**RE: APPROVAL WITH MODIFICATIONS
PROPOSED WELL DESIGN FOR REGIONAL AQUIFER MONITORING WELL R-76
LOS ALAMOS NATIONAL LABORATORY
EPA ID#NM0890010515
LANL-22-019**

The New Mexico Environment Department (NMED) has received the United States Department of Energy (DOE) *Proposed Well Design for Regional Aquifer Monitoring Well R-76* (Well Design) dated and received on December 22, 2023 and referenced as EM2023-0861.

Table 1: Selected photographs of the Cerros del Rio (CDR) and Puye contact chip record at 8x magnification.

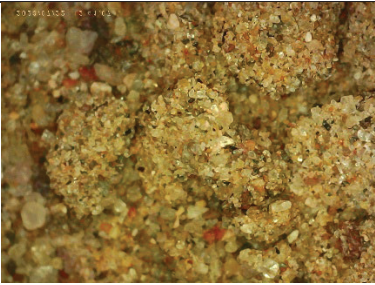
DOE describes the lithology at the contact of Cerros del Rio Basalt and Puye as Puye at first contact (675-680 ft bgs). At this location NMED's evaluation demonstrates that the neutron count remains high and a composition of approximately 80% Basalt and 20% Puye (Table 1). NMED advises that the change of formation should be called when the Puye indicator clast dominates the sample, rather than when it first appears in trace amounts. From NMED evaluation, it is not apparent until reaching depths of 720-725 ft bgs that the Puye clast count exceeds Basalt, and this corresponds with a drop in the neutron count indicating sedimentary porosities.

It may also be beneficial to designate a contact lithology for this interval, given that thin basalt flows on cold clastics would likely result in different hydrogeological characteristics than either a thick basalt flow or the Puye beneath it.
